**PLANNED UNIT DEVELOPMENT &
SUBDIVISION STAFF REPORT**

DEVELOPMENT NAME The Pines at The Preserve Subdivision

CONTEMPLATED USE Amend Planned Unit Development Approval to allow reduced lot widths and sizes, reduced building setbacks, and increased site coverage in a single-family residential subdivision.

SITE PLAN

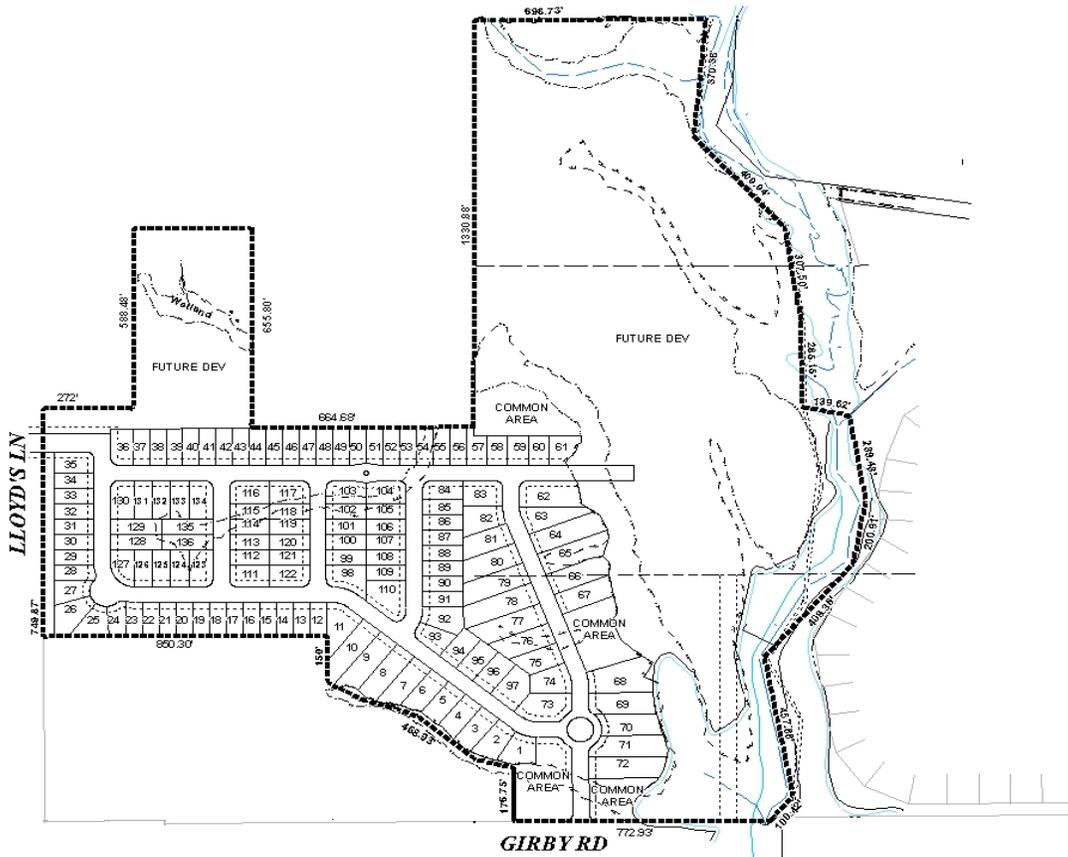
The flood zones shown on the preliminary plat should be revised to more accurately delineate the FEMA designated flood zones.

Detention should be accomplished above the 100 year flood elevation. And, the predevelopment runoff coefficient to be used for the existing wetlands areas should be accurate for wetland areas.

The applicant states that common area will be provided for stormwater detention, landscaping and green areas, along with areas located in designated flood plain areas and wetlands; however, 2.1± acres of wetland area must be disturbed, permitted, and mitigated for the development of this project. It should be noted that some areas shown on the previous plan as wetlands are not incorporated into some lots.

The site adjoins a creek and as such the area may be considered environmentally sensitive; thus the approval of all applicable federal, state and local agencies would be required. Additionally, there are wetlands on the site, some of which encroach into some lots; and while reduced lot widths and sizes are allowed, the applicant should submit documentation prior to the recording of the final plat, which illustrates that there is adequate buildable area (5,000 square feet based on the minimum lot) for those lots containing wetlands.

RECOMMENDATION **Planned Unit Development** Based upon the preceding, this application is recommended for approval subject to the following conditions: 1) full compliance with the Traffic Engineering comments (driveway number, size, location and design to be approved by Traffic Engineering and conform to AASHTO standards, traffic calming measures should be included in the development; 2) full compliance with Engineering comments; 3) the provision of a street stub to the land locked parcel to the North in the vicinity of Lots 44-55; and 4) that the applicant obtain all necessary federal, state and local permits.

Subdivision With a waiver of Section V.D.2., the plat will meet the minimum requirements of the Subdivision Regulations and is recommended for Tentative Approval subject to the following conditions: 1) full compliance with the Traffic Engineering comments (driveway number, size, location and design to be approved by Traffic Engineering and conform to AASHTO standards, traffic calming measures should be included in the development; 2) full compliance with Engineering comments; 3) the provision of a street stub to the land locked parcel to the North in the vicinity of Lots 44-55; and 4) that the applicant obtain all necessary federal, state and local permits.
